**ZONING AMENDMENT
& SUBDIVISION STAFF REPORT****Date: January 19, 2017****APPLICANT NAME**

Parkway Corner Subdivision

LOCATION3300 Dauphin Island Parkway
(Southwest corner of Dauphin Island Parkway and Gill Road)**CITY COUNCIL
DISTRICT**

REQUEST Subdivision, Rezoning from B-2 to B-3

SITE PLAN

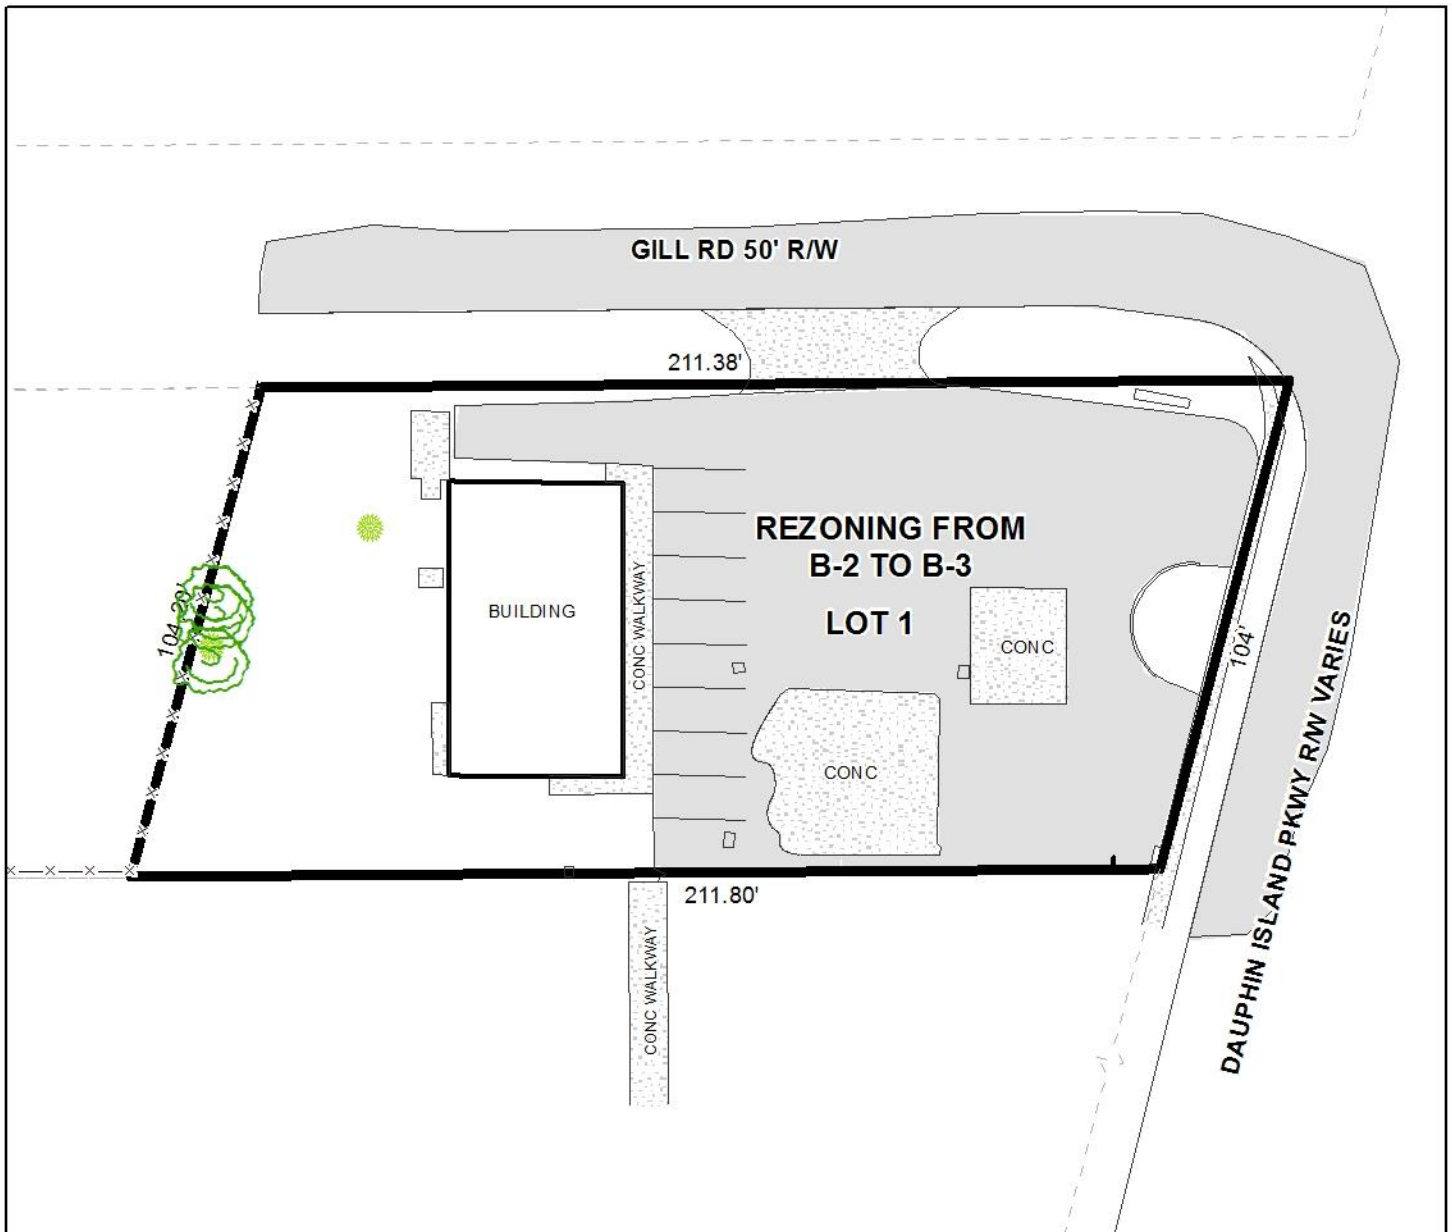
A revised site plan was submitted on January 11, 2017 for the Zoning aspect of the applications. No changes from existing conditions were indicated on the revised site plan, and no narrative was provided indicating that any changes would be undertaken to comply with the original rezoning conditions of approval for the site from R-1 to B-2, which occurred in 2005: full tree and landscaping compliance, parking compliance, storm water compliance and curb-cut limitations. Additionally, no information to identify the auto sale display area was provided, thus staff cannot determine if there will be sufficient maneuvering area on site for customers to access parking spaces, and for vehicles to be delivered for sale by truck and unloaded on the site.

The existing building on the site is approximately 2,100 square feet, thus 7 parking spaces are required. The correct number of parking spaces is shown on the site plan, however, the accessible parking space does not include the necessary access aisle adjacent to the parking space for van accessibility. Thus the site plan does not appear to comply with the requirements of the 2012 International Building Code/ 2009 ICC/ ANSI 117.1.

- 1) submission of an application for a one lot Subdivision by December 21, 2016; and
- 2) revision of the site plan to show customer parking areas, accessible parking areas, auto display areas, a dumpster if one will be used, and any other anticipated site improvements required as part of the 2005 zoning approval.
